### Correspondence.

Mr. G. P. ANDERSON considered that the official explanation Mr. Anderson. given of the cause of the crack, and briefly referred to on pp. 420 and 421, was unsatisfactory, and submitted an alternative explanation based principally on changes of temperature. The official explanation, as propounded by Professor Hörnell, was that the rock swelled with increased moisture-content due to the head of water in the headrace. It was true that the rock would expand rapidly with increase of moisture when it was nearly dry, but the change became very slight as saturation was approached. It had also been shown that the rock was always practically saturated, even in exposed faces, whereas the floor of the headrace had previously been covered by a swamp. The great elasticity of the country rock had been referred to; the elastic moduli of the rock, concrete and steel were approximately as 1 : 10 : 100. At the time of the crack there were three penstocks in operation (cross section, Figs. 1, Plate 8) and three others complete but empty. As those penstocks were 12 feet in diameter, lined with steel encased in not less than 2 feet of concrete, they provided, relatively speaking, a

Fig. 3.

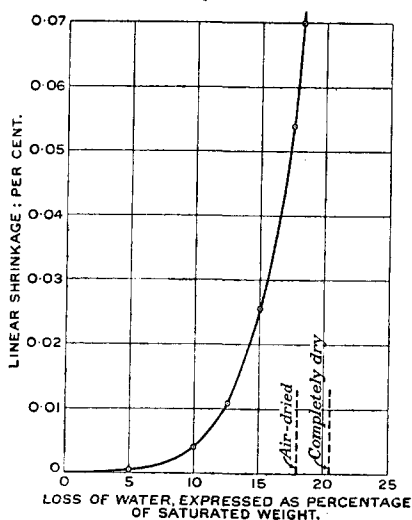
Mr. G. P. Anderson's theory of temperature-contraction as the cause of the main crack was worthy of full consideration, but the

Mr. Furkert. in the face of a cliff 150 feet above the nearest water and only 6 feet from a surface exposed to the sun nearly all day. The details of tests on that specimen were given below. They showed that the rock in nature contained no space available for taking in more water.

These figures indicate that all the pore-space in the specimen was filled with water.

Samples even 1 foot from the surface had been found to be hardly less saturated. Had the general run of the rock been less than fully saturated even to the extent of 25 per cent. of the possible water being absent, the swelling due to that amount of extra absorption would have been negligible. Saturated specimens had been gradually dried and the progressive shrinkage measured (*Fig. 3*). The results showed that absolutely dry rock would expand considerably when wetted, but that rock in a state of nature, even if not absolutely saturated, would on being fully saturated only expand to an infinitesimal extent.
